# CITY OF ALBUQUERQUE

RE: **Volcano Cliffs Subdivision Lot 7, Block 10, Unit 18**  
**6509 Petirrojo Rd. NW**  
**Grading and Drainage Plan**  
**Engineers Stamp Date 12/14/18 (D10D003P7)**

## DRAINAGE AND TRANSPORTATION INFORMATION SHEET (REV 6/2018)

LOT 7, BLOCK 10, UNIT 18 VCS  
6509 PETIRROJO ROAD, NW  
GRADING PLAN

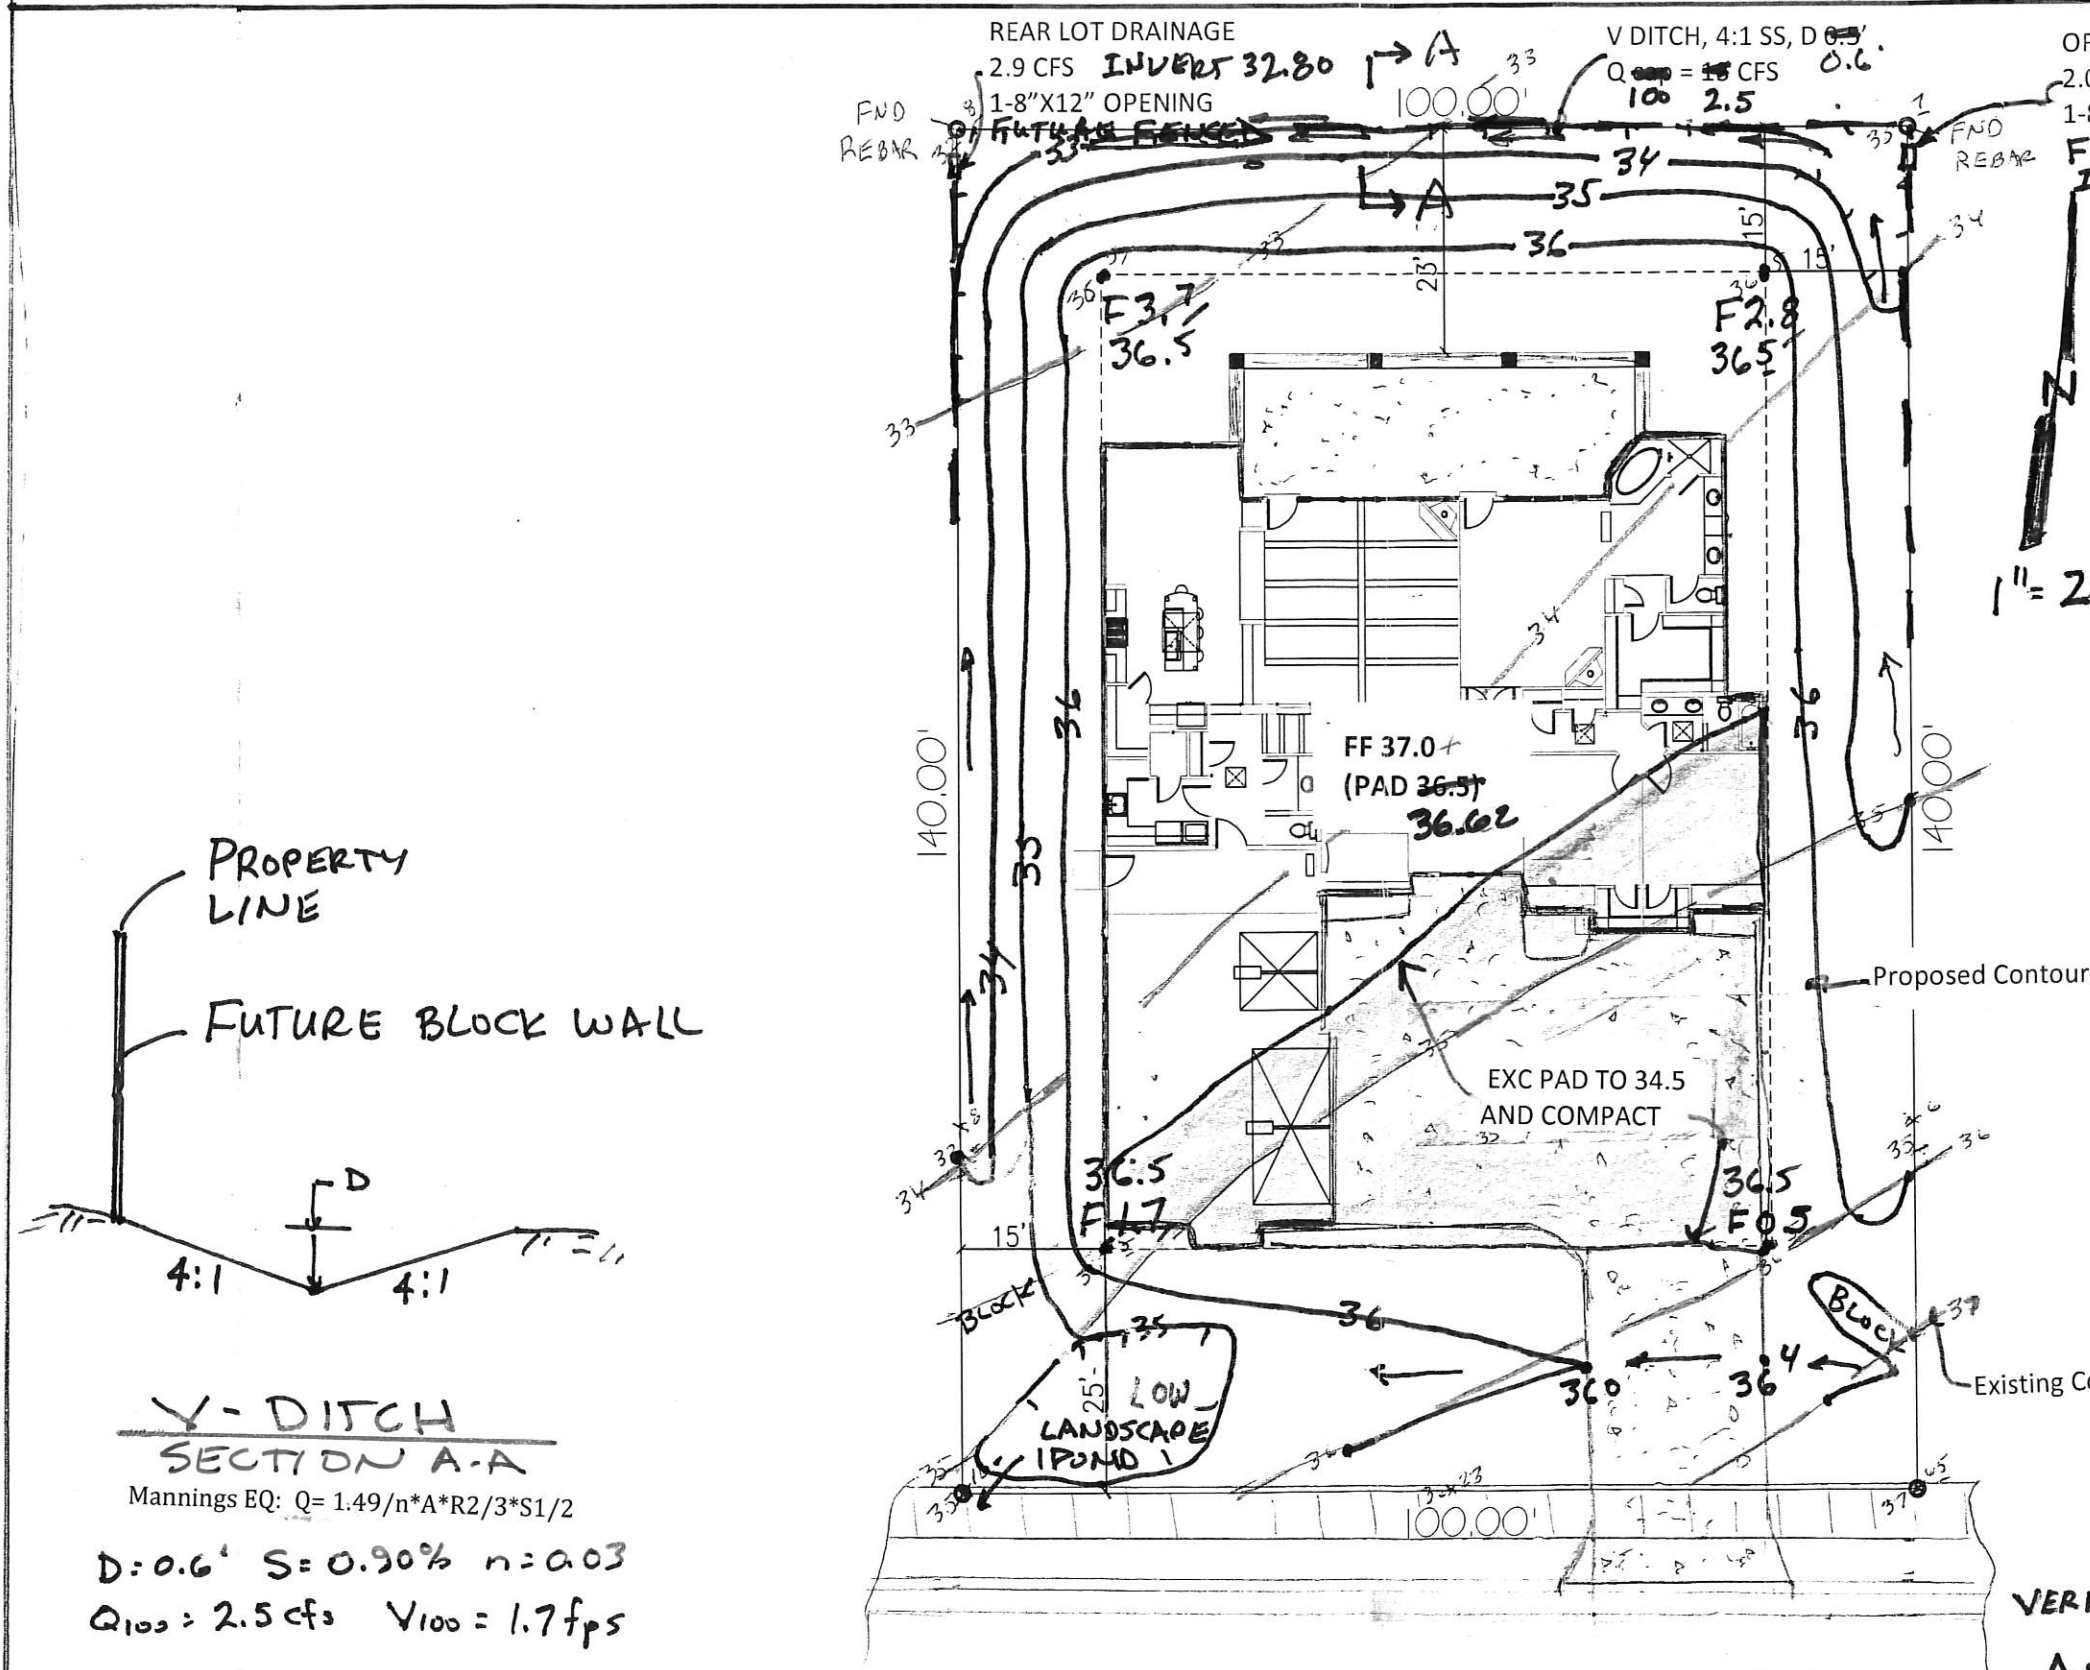
Based upon the information provided in your submittal received 12/14/18, this plan is approved for Building permit.

Please attach a copy of this approved plan to the construction sets in the permitting process prior to sign-off by Hydrology. Also, please advise the owner/contractor that a separate wall permit must be obtained and this approved grading plan dated 12/14/18 must be provided with the wall permit application. Also, please advise the contractor/owner that the ponds must stay in place or CO will not be granted.
